ADDENDUM NO. 3

RE: Architect's Project #: 2301 A1

Project: **Bandera County Visitor Center
Phase 2 – Historic Stabilization**

1 1877 COURTHOUSE-REHABILITATION-ROOF
1/4" = 1'-0"

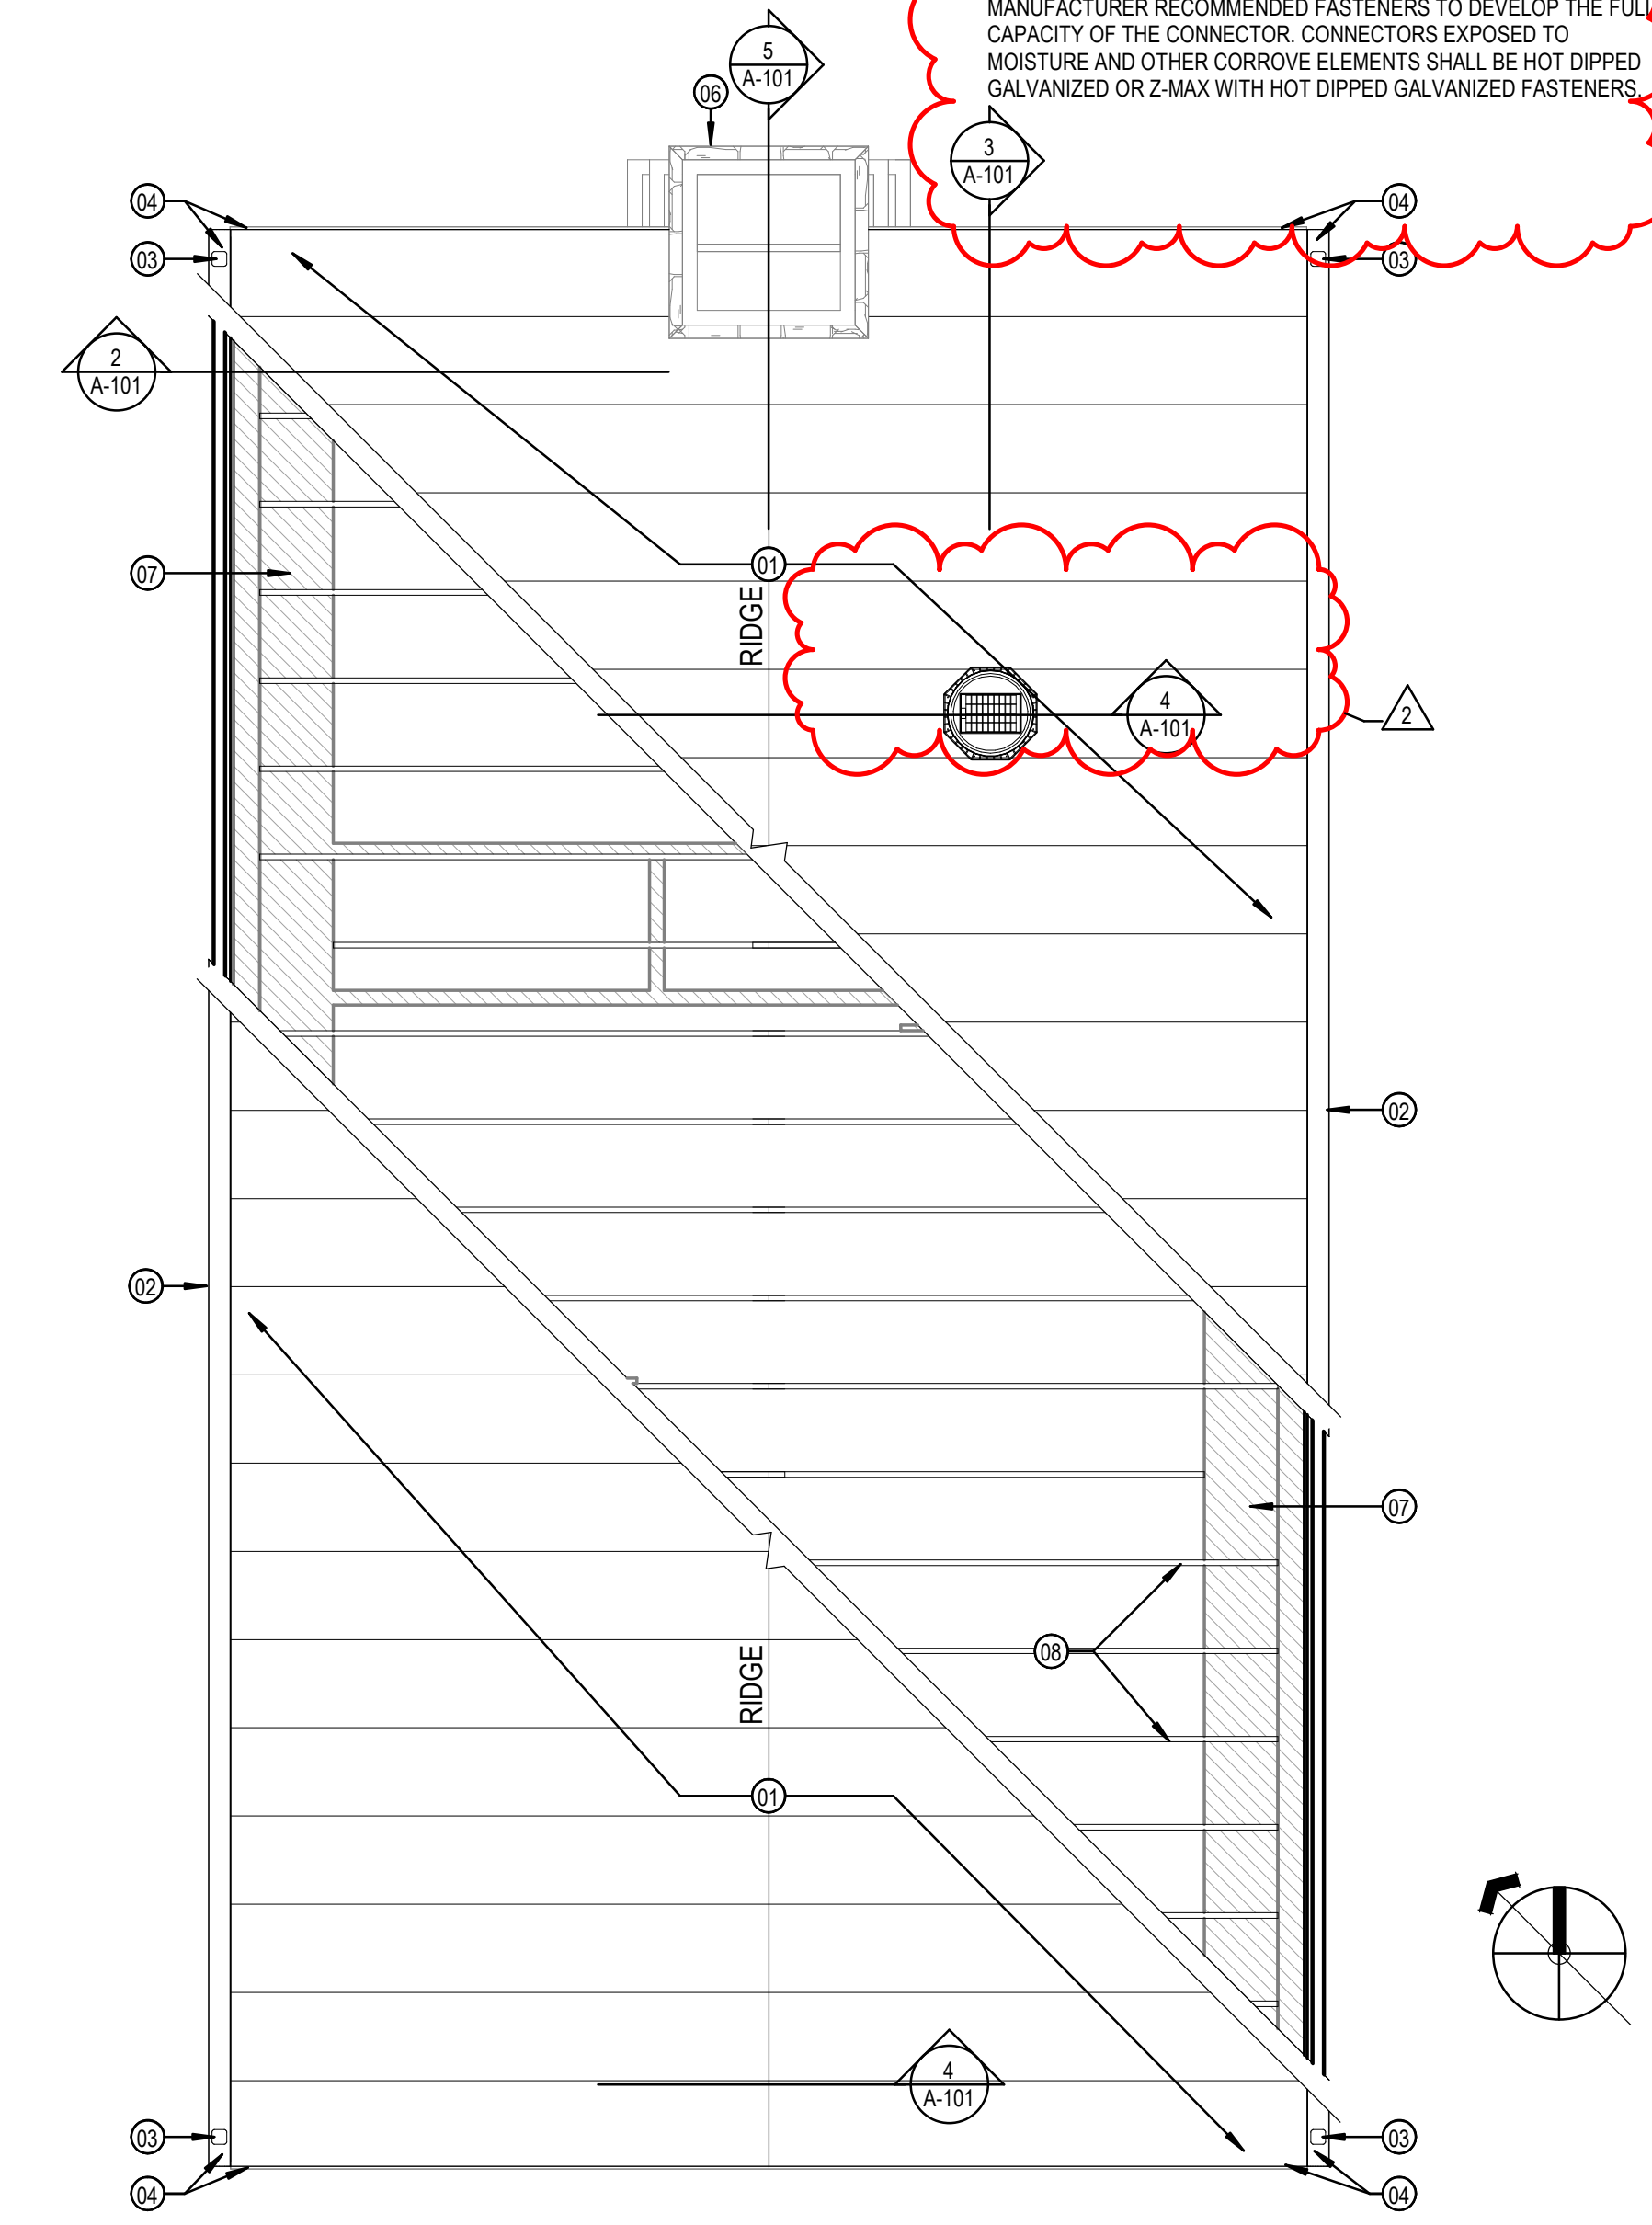
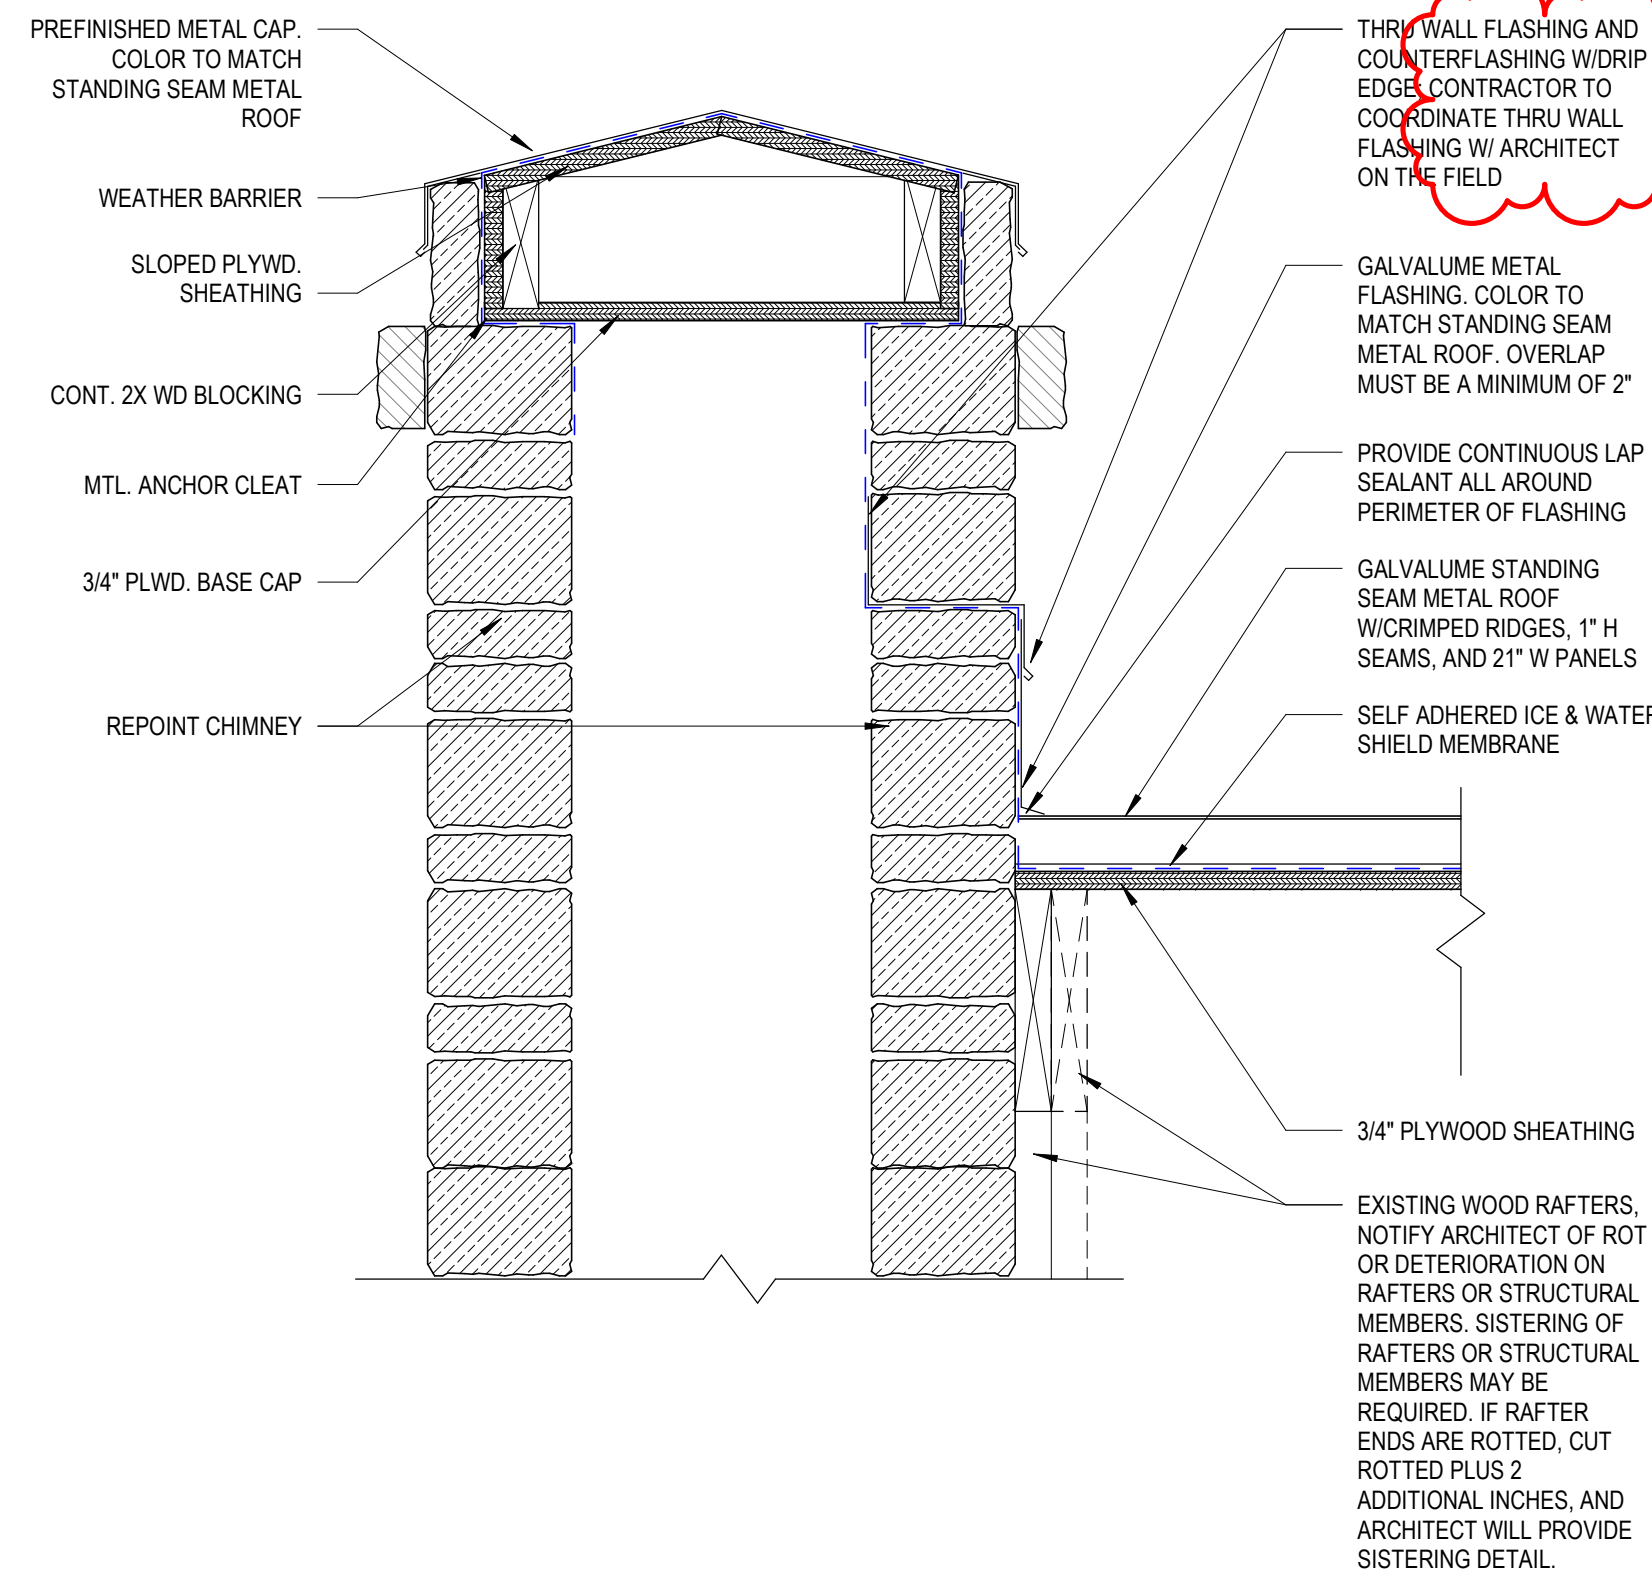
- c. Added solar powered roof vent to details 1 and 4
 - d. Clarified sistering note on detail 4
 - e. Clarified thru wall flashing note and added images to detail 5.

3. For the rafter replacement or sistering is there a spec or engineered requirement?
[Refer to Wood Framing Notes on Sheet A-101 for details.](#)
4. Detail 2/A-101 indicates to install ¾" plywood decking directly to the existing wood rafters. What grade of plywood is required?
[Refer to Wood Framing Notes on Sheet A-101 for details.](#)

5. Detail 2/A-101 indicates to install ¾" plywood decking directly to the existing wood rafters. It is assumed this decking must transfer diaphragm lateral loads to the rafters and resist uplift loads, however, no fasteners are specified. Will the client please provide the required fasteners to resist wind lateral and uplift loads?
[Refer to Wood Framing Notes on Sheet A-101 for details.](#)

6. The drawings do not include any details for fastening the existing rafters to the existing masonry walls to transfer wind lateral and uplift forces. Please confirm the contractor is not required to install any new fasteners or connections at the rafter-to-wall intersections.
[Refer to Wood Framing Notes and Nailing Schedule on Sheet A-101 for details.](#)

9. Please advise if R-Vent Roof Ventilation Mat by Advanced Building Products would be acceptable.
[No](#)
10. Can you please advise if the vent membrane may be removed from the scope due to the crimple ridge – or if there is a different method intended to vent the roof. The crimped ridge will not allow for the venting membrane to function as intended.
[The vent membrane must remain. Please refer to detail 4/A-101.](#)

- WF-1 LUMBER SHALL CONSIST OF DOUGLAS FIR, KILN DRIED W/ A MOISTURE CONTENT OF 19% MAXIMUM AT THE TIME OF INSTALLATION, UNLESS NOTED OTHERWISE.
- WF-2 ROOF SHEATHING SHALL BE 5/8" EXTERIOR PLYWOOD OR OSB OVER WOOD JOISTS. PROVIDE ADEQUATE BLOCKING, TONGUE AND GROOVE EDGES OR PLYCLIPS (2 FOR 48" SPAN), USE 10d NAILS (1/2" PENETRATION) AT 6" O.C. AT END JOINTS.

CONNECTION	NAILING	LOCATION
1. CEILING JOIST TO PLATE	(3) 8d COMMON	TOENAIL
2. CEILING JOIST, LAPS OVER PARTITIONS	(3) 16d COMMON	FACENAIL
3. CEILING JOIST, TO PARALLEL RAFTERS	(3) 16d COMMON	FACENAIL
4. RAFTER TO PLATE	(3) 8d COMMON	TOENAIL
5. COLLAR TIE TO RAFTER	(3) 10d COMMON	FACENAIL
6. ROOF RAFTER TO 2x RIDGE BEAM	(2) 16d COMMON	TOENAIL
	(2) 16d COMMON	FACENAIL

11. Re: 5/A-101: Please provide more detail at top of chimney. If this chimney is to be functional, there is a concern over wood being exposed to the smoke/heat as shown. Framing is not clear as to provide for ventilation. Flashing details are also not clear (re: extent of waterproofing, through wall flashing).

- Chimney will not be functional. Refer to detail 5/A-101 for clarification on flashing detail.
12. Is the through wall flashing at chimney, indicated by blue dashed lines, existing? If required to be new, is the through wall portion to be at roof side only? If required, is there a specified level or distance (above roof, below cap or stone course) that through wall is to be achieved? Is material to match galvalume metal specified at roof flashing?
The blue dashed line indicates new through wall flashing that is to be applied only to the roof side of the wall, refer to detail 5/A-101 for clarification on how to install. Flashing to match galvalume metal specified at roof.
